POBL
Herbert Road, Newport

Engineering Layout
Phase 2B

Sep'18 1795 201 T

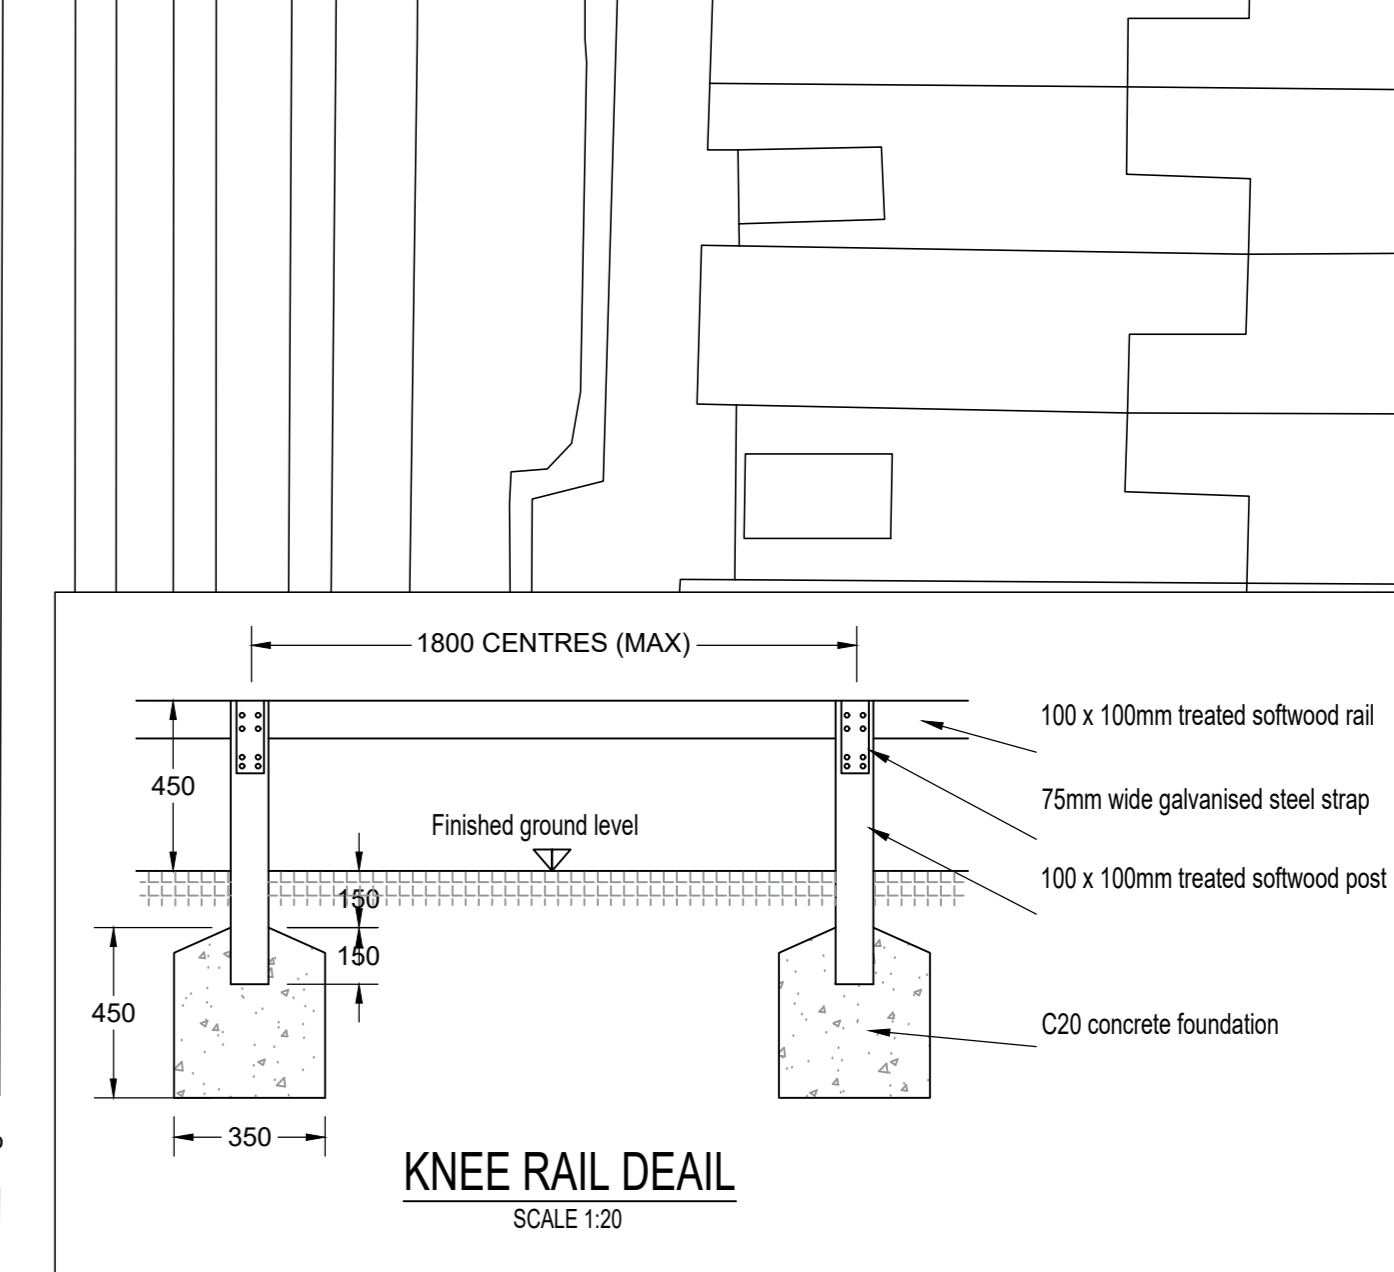
Connection into existing DCWW sewer S131897002 via 1.5m backdrop with IL 6.32 at point of connection

Reduce CL of F5 by 650mm to 9.10m
